UHF ASK/FSK Receiver

ATA5721
ATA5722

2. Change Notice Based on Datasheet ATA5823/ATA5824 -- UHF ASK/FSK Transceiver Rev. 4829D-RKE-06/06

Figure 1-1. Pinning QFN48

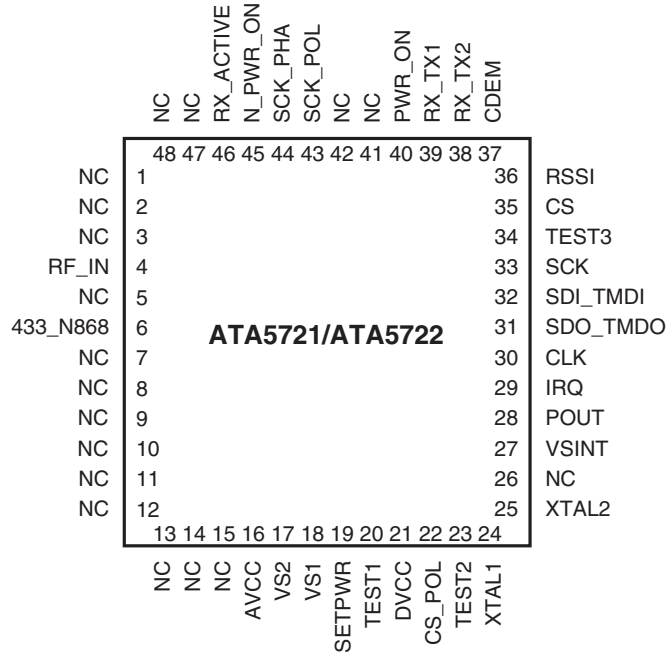
Unlike the transceiver, the receiver does not have the transmit functionality, and pins 8, 9 and 10 are not connected. The only change to the receiver is that it has a different bonding inside to disable the TX functionality.

- IC changed from transceiver to receiver due to removed TX functionality
- Device type numbers changed from ATA5823 to ATA5721 (313-MHz to 316-MHz version) and from ATA5824 into ATA5722 (433-MHz to 435-MHz version)
- No TX operation mode available due to removed bondwires of pins 8, 9 and 10
- Pins 8, 9 and 10 are NC (not connected) and have to be soldered to GND on the PCB
- No full-duplex operation mode possible
- All descriptions of TX operation in half-duplex mode are not valid
- The receiver type ATA5722 is only specified and tested in the frequency range of 433 MHz to 435 MHz, receive functionality in the 867-MHz to 870-MHz frequency band is neither specified nor tested.
- All descriptions of 867-MHz to 870-MHz applications are not valid.

Page	Note	Category of Change ⁽¹⁾
2	Benefit is a less demanding specification for the microcontroller due to handling of power-down mode, delivering of clock, and complete handling of receive protocol and polling	CH
3/4	Figure 2-1 "Pinning QFN48" and Table 2-1 "Pin Description" contains 3 pins (8, 9 and 10) changed to NC (Not Connected). Pin 6 (433_N868) still selects the input frequency range, but 868 MHz is not supported	CH CH
3/5	Figure 1-1 "System Block Diagram" and figure 2-2 "Block Diagram" contain an RF rReceiver section without a power amplifier part	CH
5	Figure 2-2 "Block Diagram" contains the input frequency range selection with pin 6, but 868 MHz is not supported.	CH
6/7/8	Application circuits figure 3-1, 4-1 and 5-1 are not valid Application circuit figure 6-1 is still valid, except the transmit application hints and the possibility to select the input frequency range between 433 MHz and 868 MHz	NV CH
